ADMINISTRATIVE AMENDMENT (PD) ADD2021-00214

ADMINISTRATIVE AMENDMENT LEE COUNTY, FLORIDA

WHEREAS, Theta Investments N. V. Corp. filed an application for an administrative amendment to a Mixed Use Planned Development on a project known as Bayshore 57 to:

DEVIATION 8 LOT SIZE DETAIL

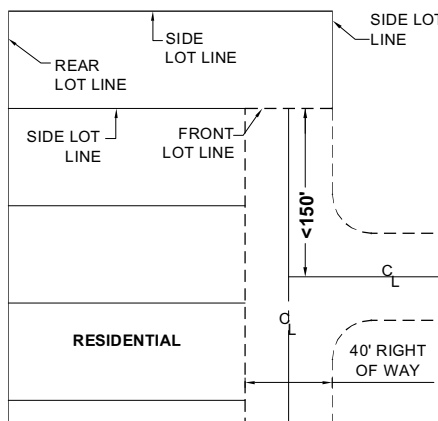
8. **Deviation 8** seeks relief from LDC Section 10-703, which establishes lot size measurements, to allow lot size to be measured as indicated on the Master Concept Plan Alternate B “Deviation 8 Lot Size Detail” is hereby APPROVED.

8. Deviation from LDC Section 10-703 to allow lot size to be measured as indicated on the Master Concept Plan.

line #3 is 90 degrees to side lot line two. Lot line three is the length of lot line one plus the width of the right of way. Using the criteria for measuring lot depth as illustrated in LDC Section 10-703, side lot line #2 would cause this end lot to fail to meet minimum lot depth. To assist in future compliance review and to clarify this request additional notes have been added to Deviation 8 detail on the plans.

PARCEL ROAD TYPICAL CROSS SECTION

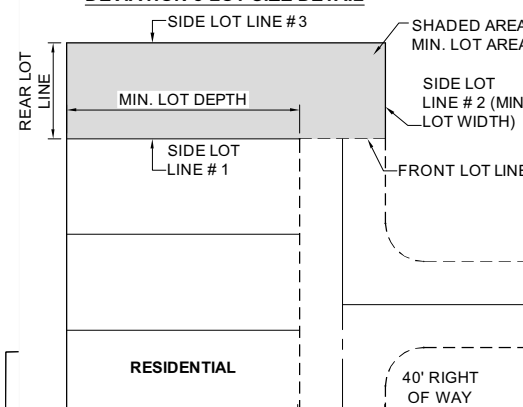
11. **Deviation 11** seeks relief from LDC Section 10-296(e)(2)h.5.ii, which requires streets to provide a sidewalk on one side of the road for residential subdivisions with a 5-foot planting strip, to allow a split 5-foot wide planting strip with 4 feet between the sidewalk and back of curb. This Deviation is hereby APPROVED.

11. **Deviation from LDC Section 10-296(e)(2)(h)(5)(ii) which requires residential streets to provide a streetside 5-foot wide planting strip to allow a split 5-foot wide planting strip on MCP Alternate B.**

Justification: This deviation request applies to parcel roads only. The applicant requests to provide a 4-foot wide planting strip between the sidewalk and back of curb, only one foot less from the LDC requirement. However, the applicant also proposes to provide a 1-foot planting strip on the other side of the sidewalk for a total of 5 feet, please see the Parcel Road Typical Cross Section on MCP Alternate B for details. The proposed planting

design will allow for utility services in the 1' planting area, while keeping the road in the center of the right-of-way. The other side of the road will consist entirely of sod, reducing heat island effect.
